### PIP5744 Bolt EV Transmission Fluid Leak at Drain Plugs

Involved Region or Country	North America
Condition	While performing other repairs or inspections, the technician may notice a small transmission fluid drip around the drain plug. There may be oil found in the air deflector panel upon removal. At this time, customers are not likely to observe this issue directly.
Cause	Drain plugs did not meet dimensional requirements.

Retrofit plugs (4 locations)

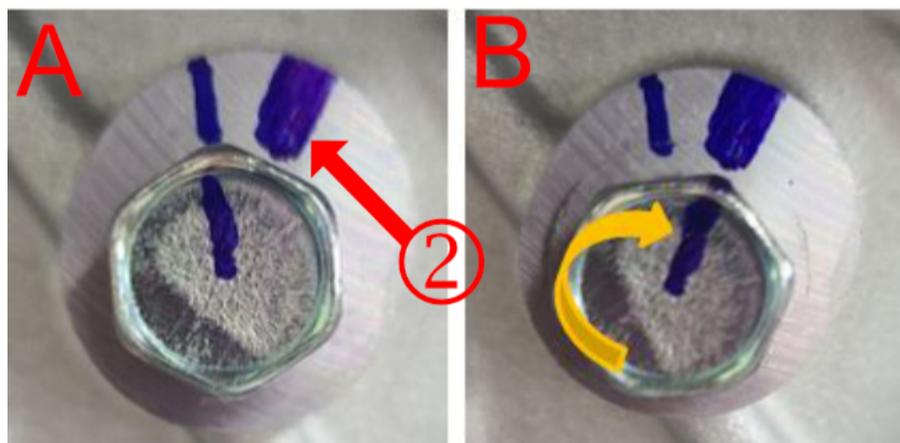
- 1 plug on gear box (#1)
- 3 plugs on end cover (#2,#3,#4)

1) Purpose : Increase engagement of one thread pitch (4.5 - 5.5) and sealant (1-1.5 2-2.5pitch) by additional tightening (Rotation Angle : 380 - 400 degrees)

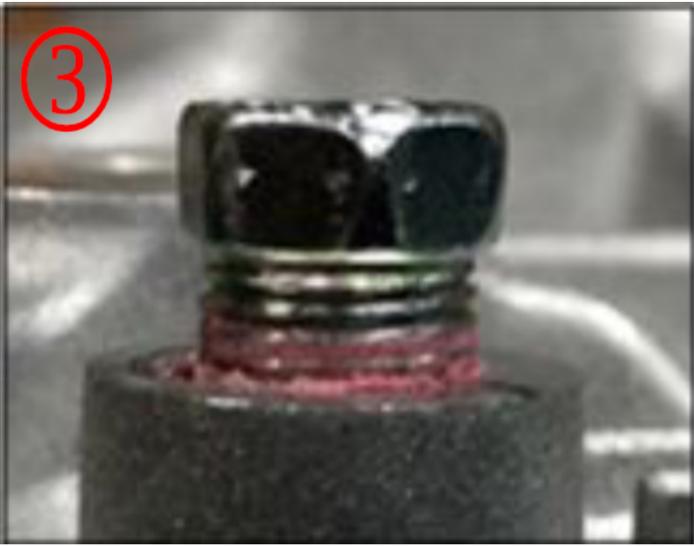
A) Inline Plug and cover for start point

B) Position of plug line to be in marked range

2) Limit band for final angle.

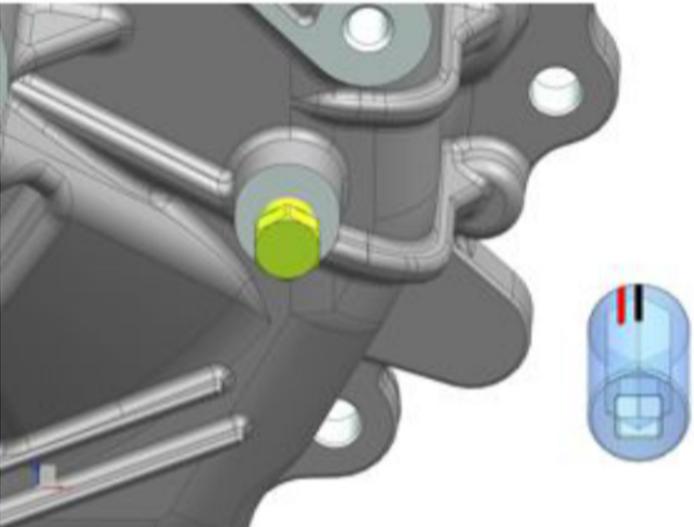
Step1 : Ensure minimum of 1 thread of sealer is visible

(Units without 1 thread will be set aside)
